PLANNING COMMISSION AGENDA

DATE: JULY 18, 2023

RE: Site Plan Review and Special Land Use – 8464 W Mt Morris Road

RE: Site Plan Review – 8464 W. Mt. Morris Road – Valero Mt. Morris Road

SITE PLAN FOR VALERO MT. MORRIS ROAD

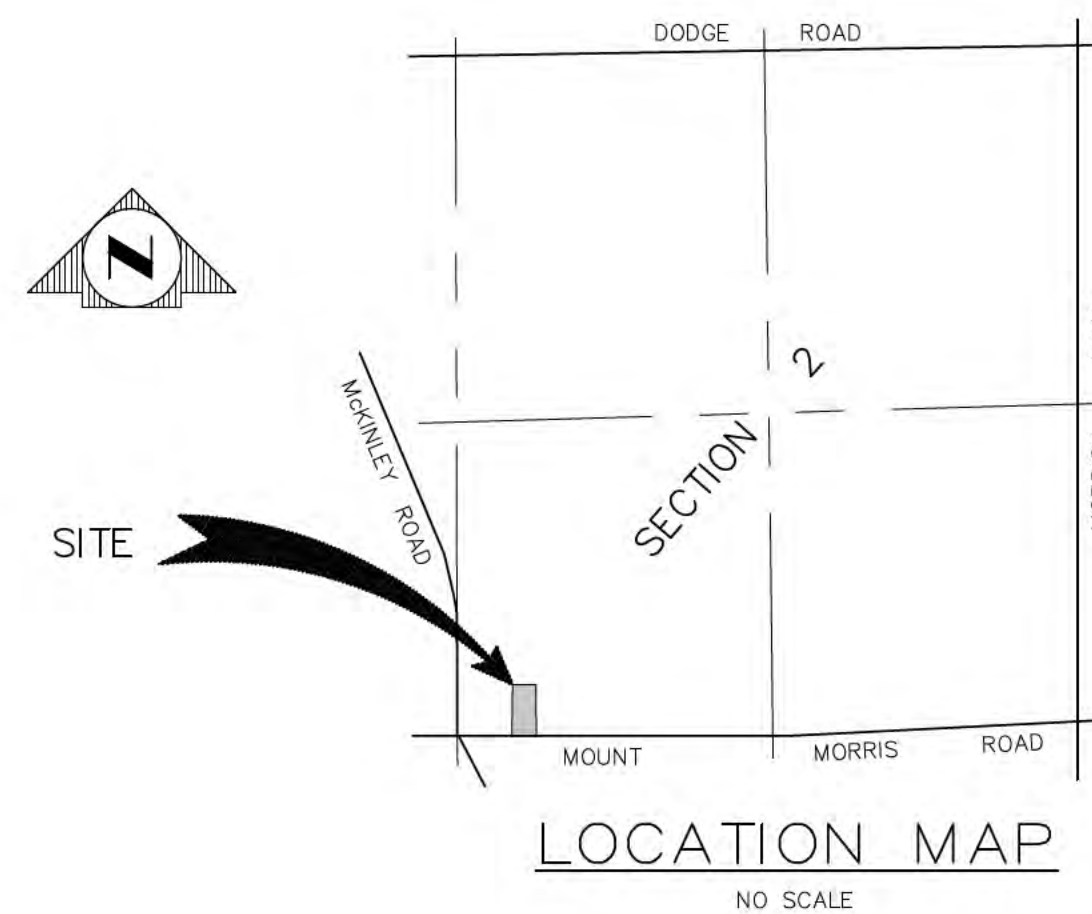
- **Sec. 36-1902(l) A location map indicating the relationship of the site to the surrounding land use for an area of not less than 1 square mile.** - The map on the cover sheet only shows the area to the north and east of the site, not land to the south and west.

1. Sheet 5, the “Concept Plan” per the cover sheet, appears to have been omitted from the submission and may be needed for a complete review.
2. No information has been provided regarding underground storage tanks or other utilities that would be related to the addition of gas pumps to the facility. Tank specifications and details; along with plan and profile views should be included within the plans.

DEMOLITION PLAN

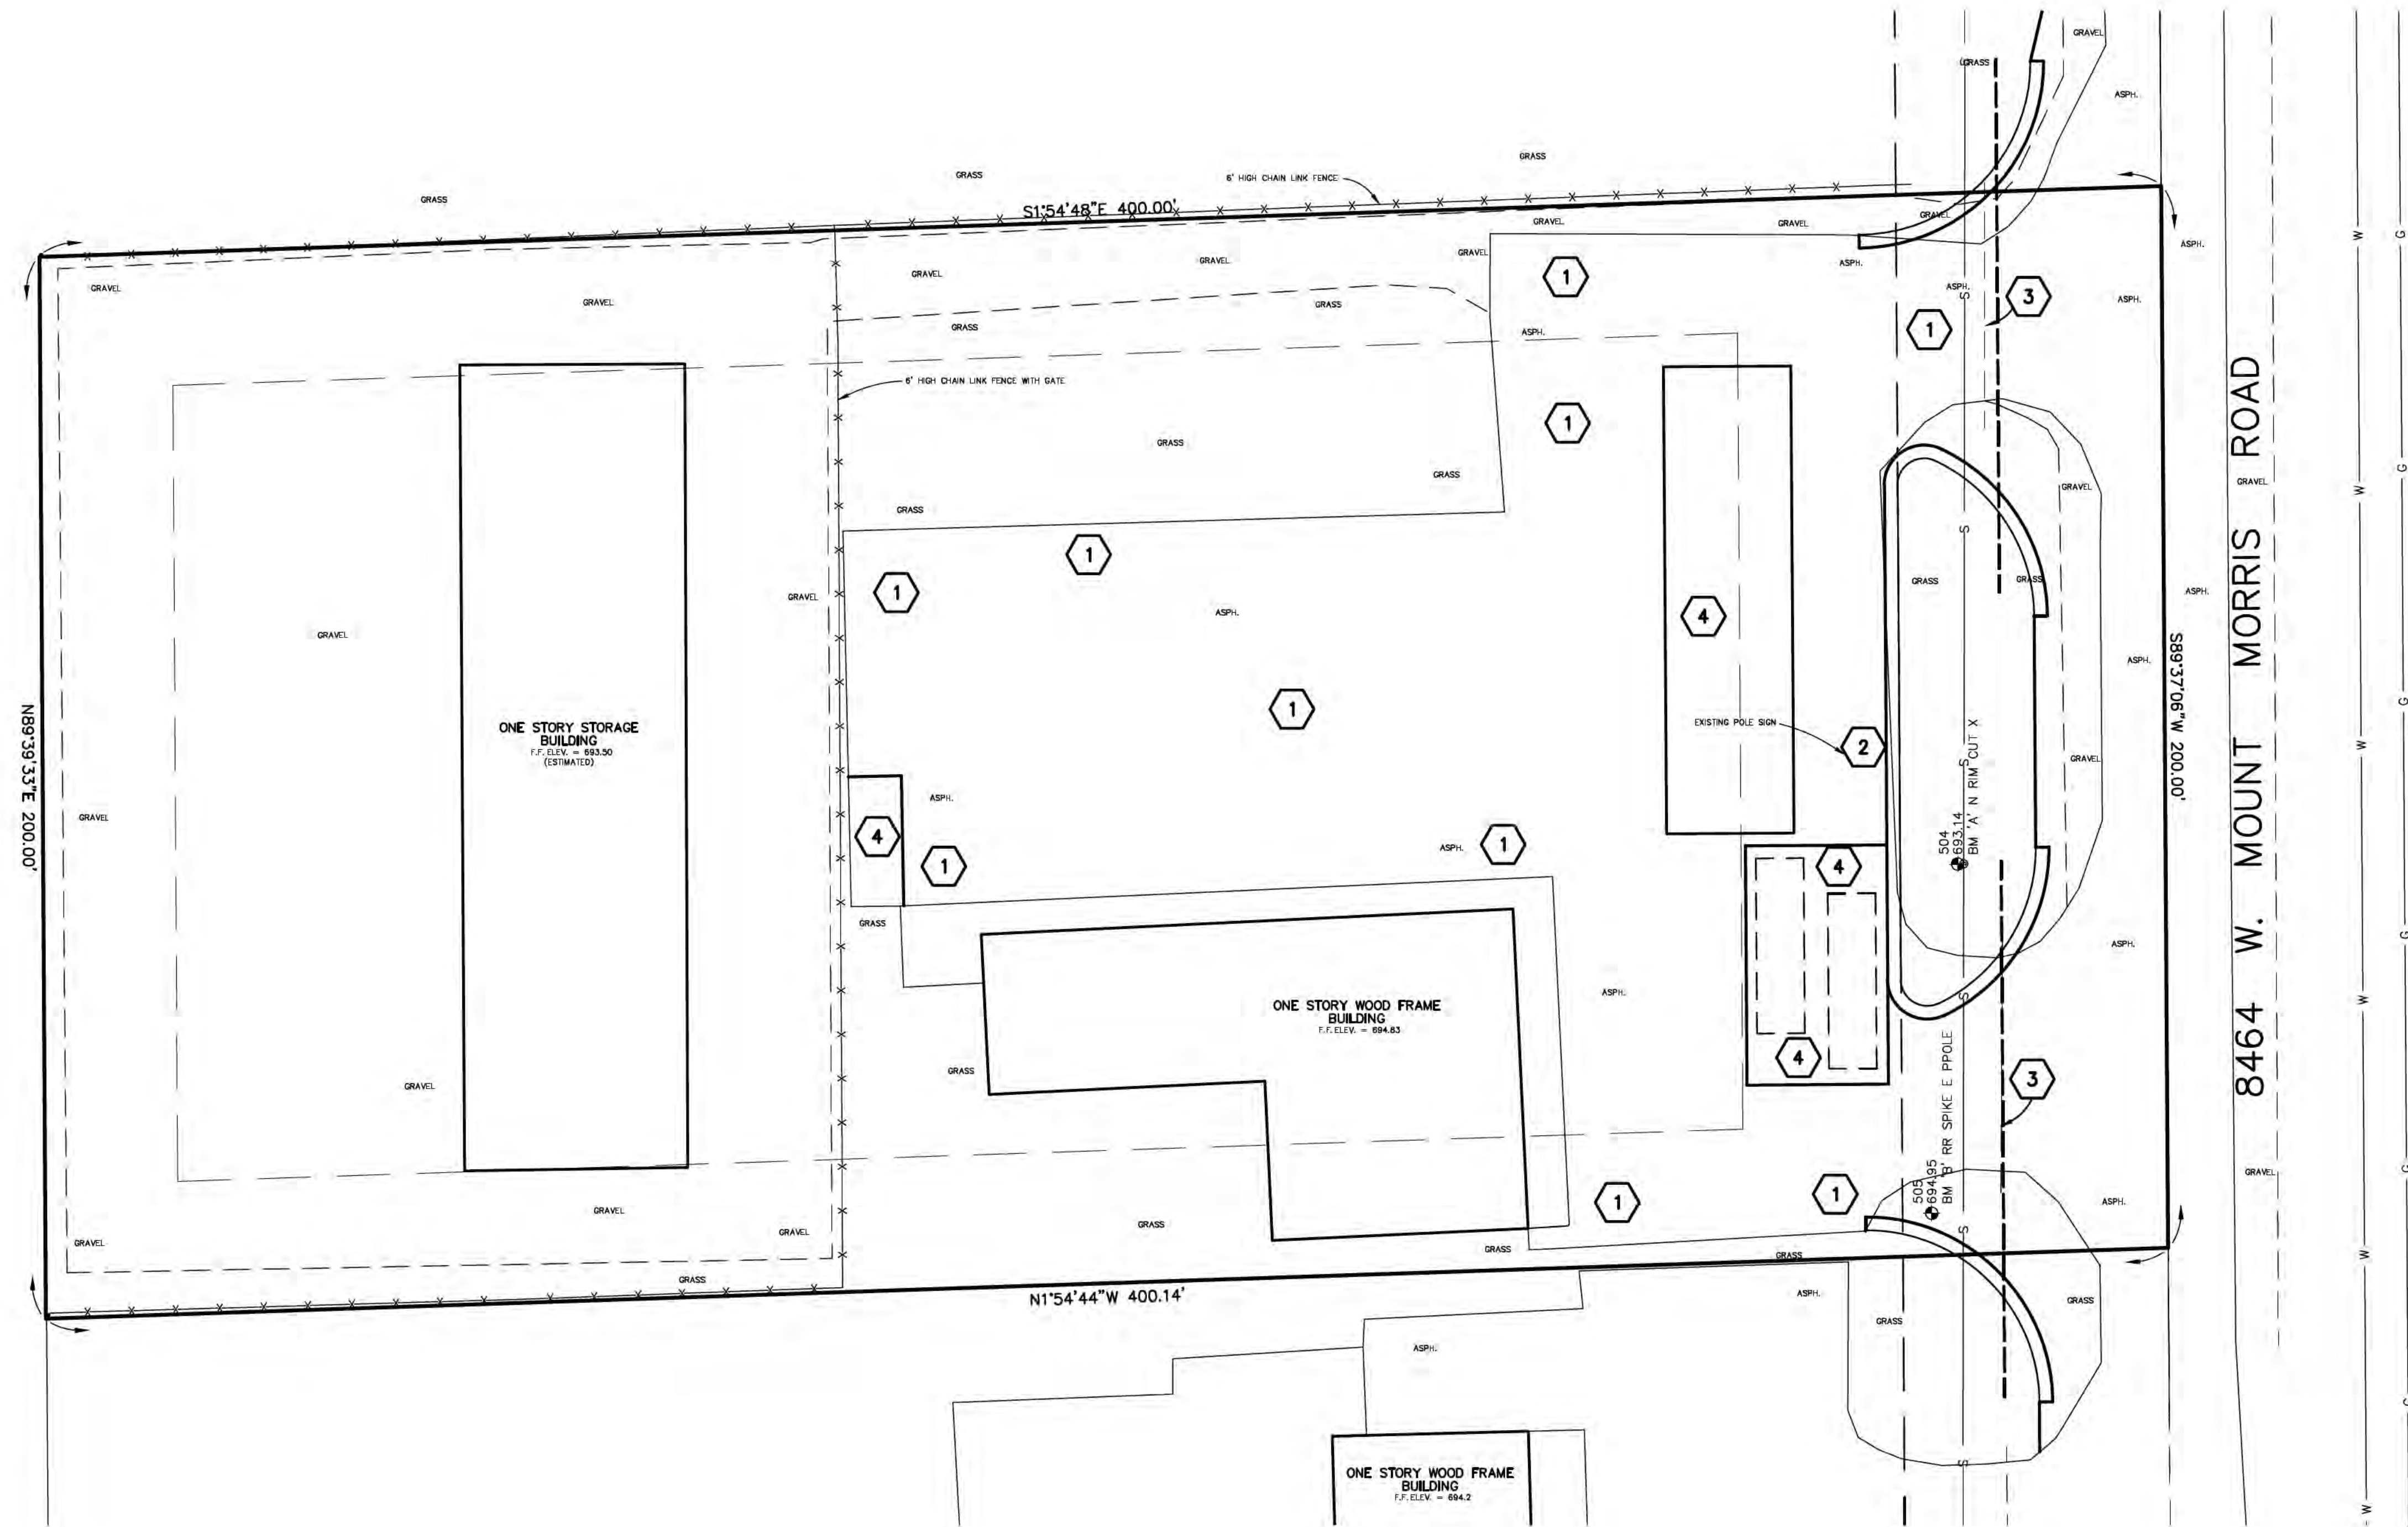
5. The existing fence along the north edge of the parking lot will likely need at least partial [temporary] removal for paving as proposed. This is not indicated on the demolition plan.

SITE PLAN

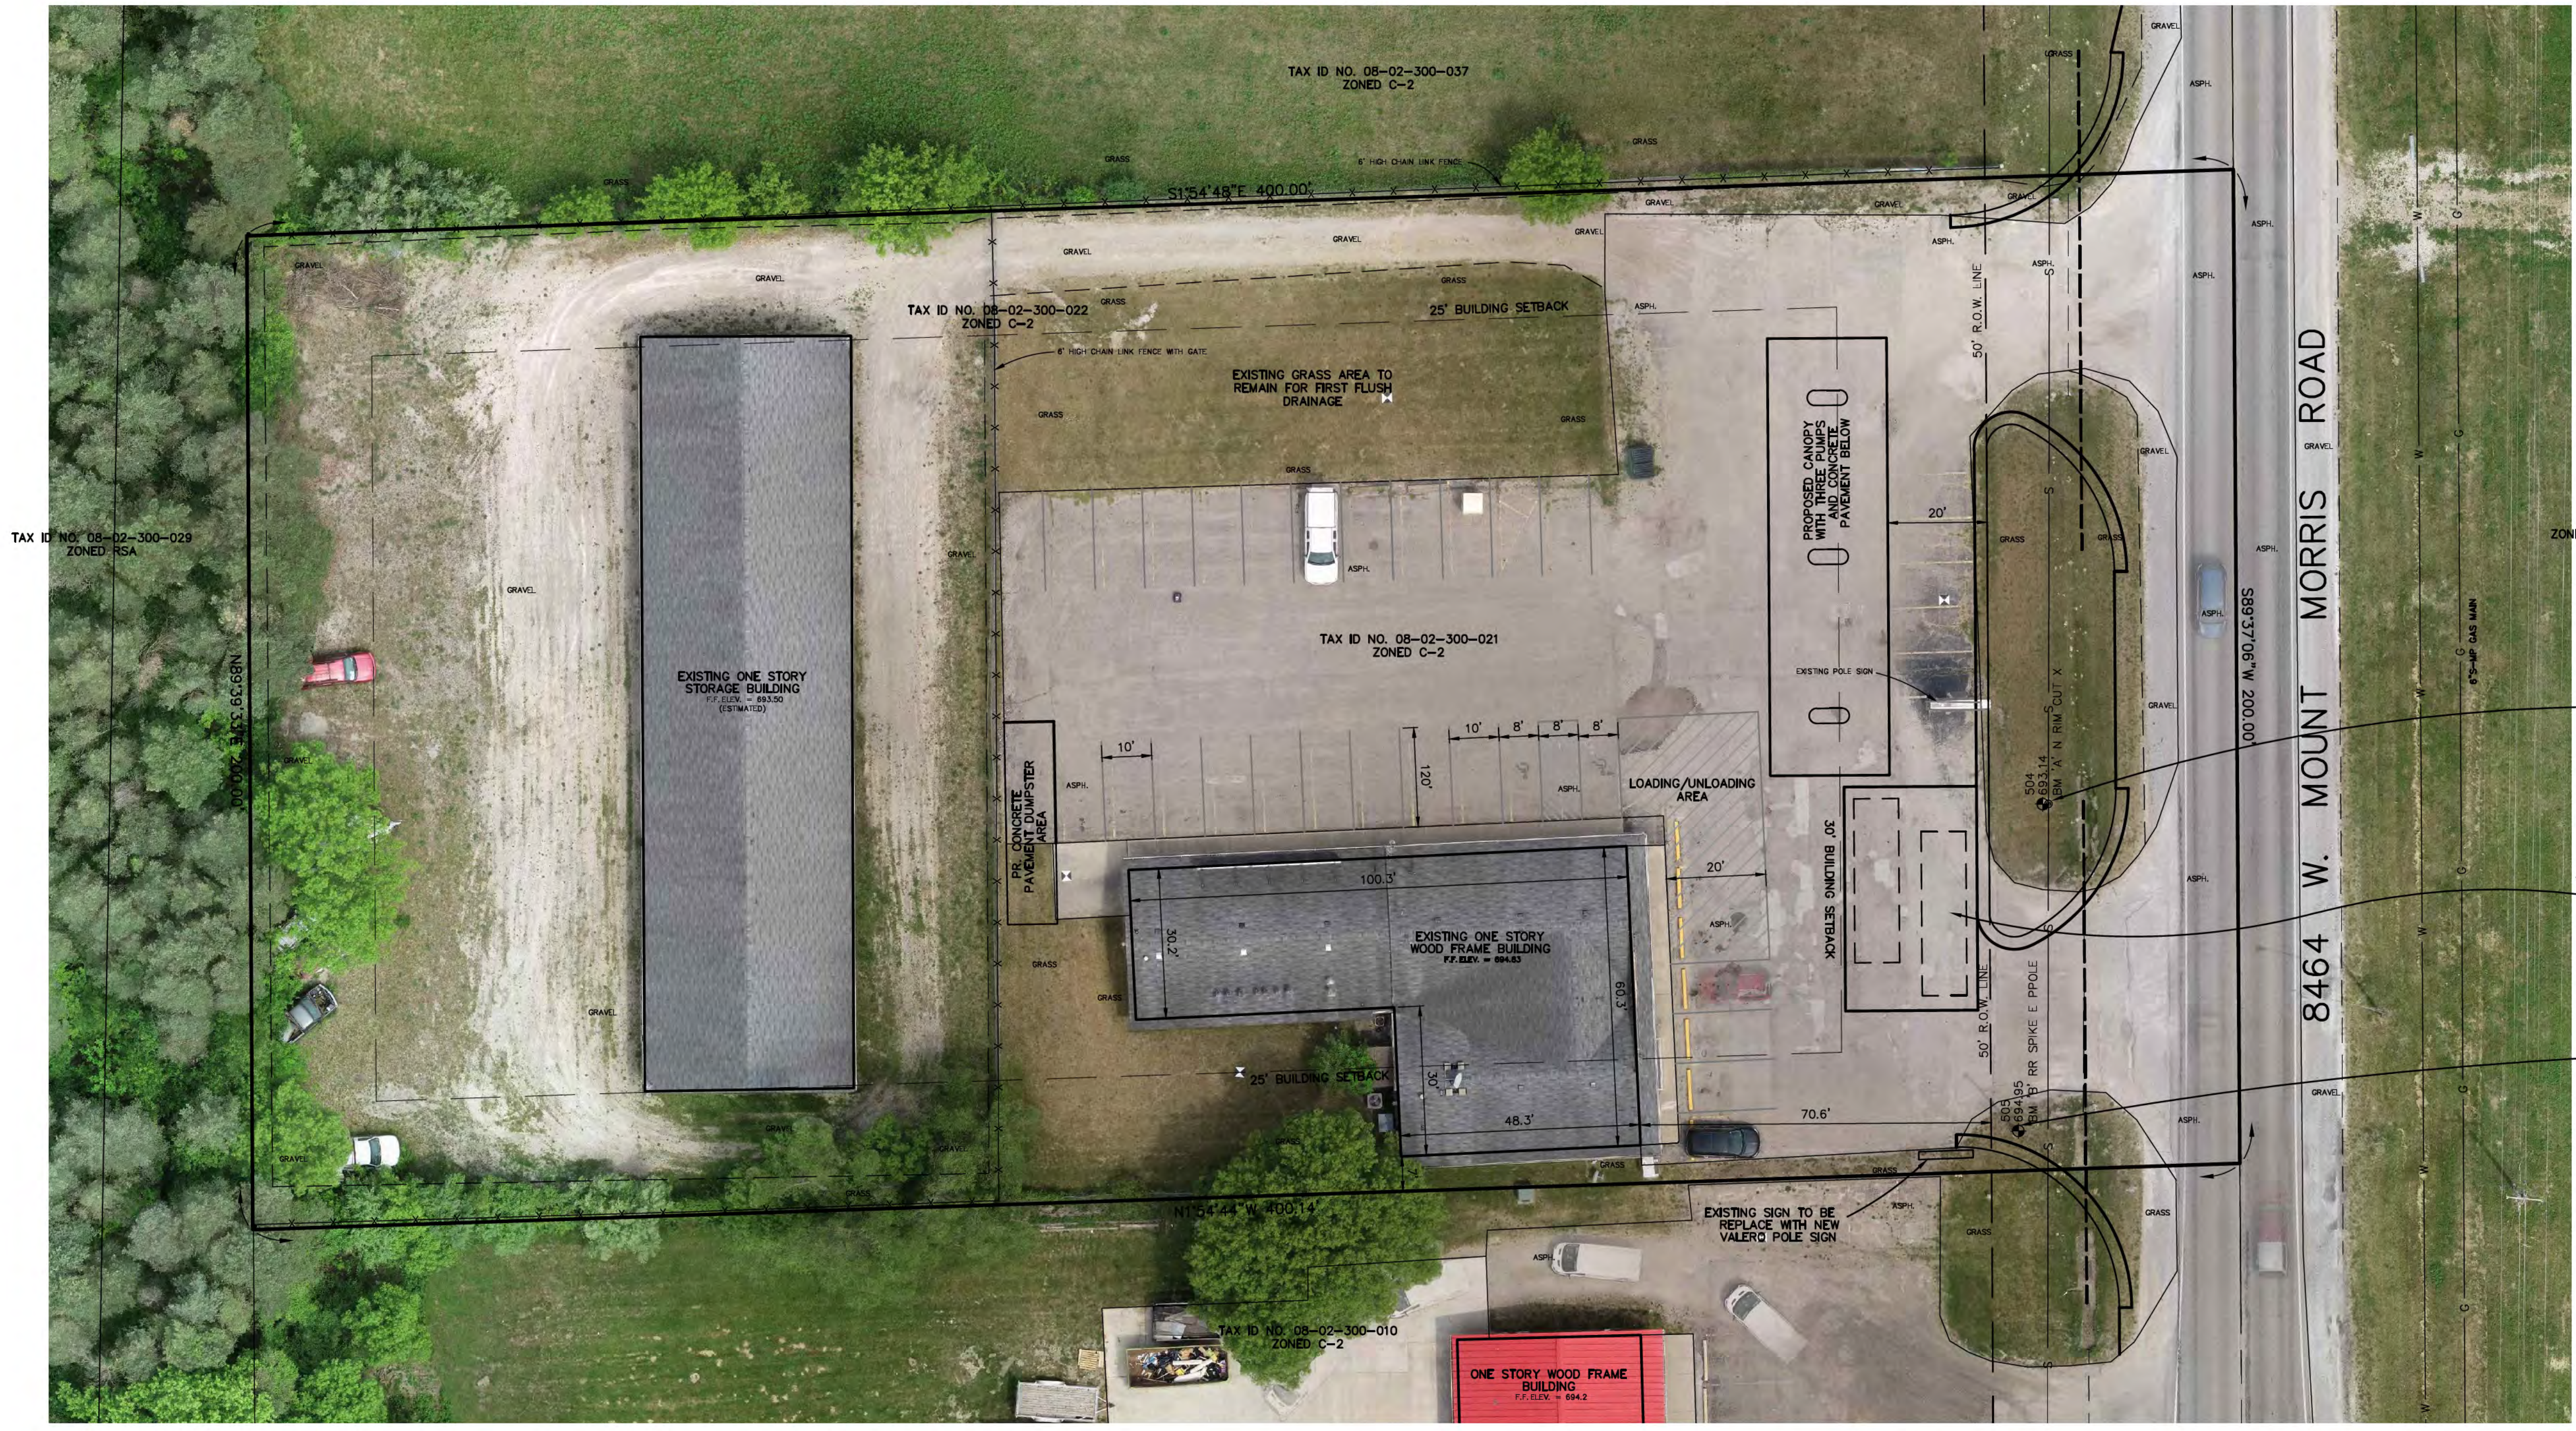
- **Sec. 36-1902(o) Location and size of interior and exterior areas and structures to be used for storage use, loading/unloading, recycling, or disposal of hazardous substances.** - The location of the loading area and storage tank for gasoline are not shown on the site plan.

- **Sec. 36-1902(p) Location of all underground and above ground storage tanks for such uses as fuel storage, waste oil holding tanks, chemical storage, hazardous waste storage, collection of contaminated storm water or wash water, and all similar uses.** - Fuel storage tanks and storm water collection are not indicated on the site plan.

- **Sec. 36-1902(q) Location of exterior drains, dry wells, catch basins, retention/detention areas, sumps and other facilities designed to collect, store to transport storm water or wastewater. The point of discharge for all drains and pipes shall be specified on the site plan.** - There is no drainage system marked in the site plan.

- **Sec. 36-1902(w) Proposed and existing utilities including water, sewer, storm sewer and lighting.** - Sheet 2 includes the location of existing water and sewer utilities, but no storm sewer or lighting utilities information is provided.

- **Section 36-409 Incinerators and Outside Trash containers** - Dumpster location is not shown on site plan. Please indicate the location of the dumpster and ensure it meets the standards of this section.

- **Section 36-501 Off-Street Parking Requirements** - 30 spots are included in the site plan. However, the two barrier free parking spots are 8 feet in width instead of the required 10 feet.
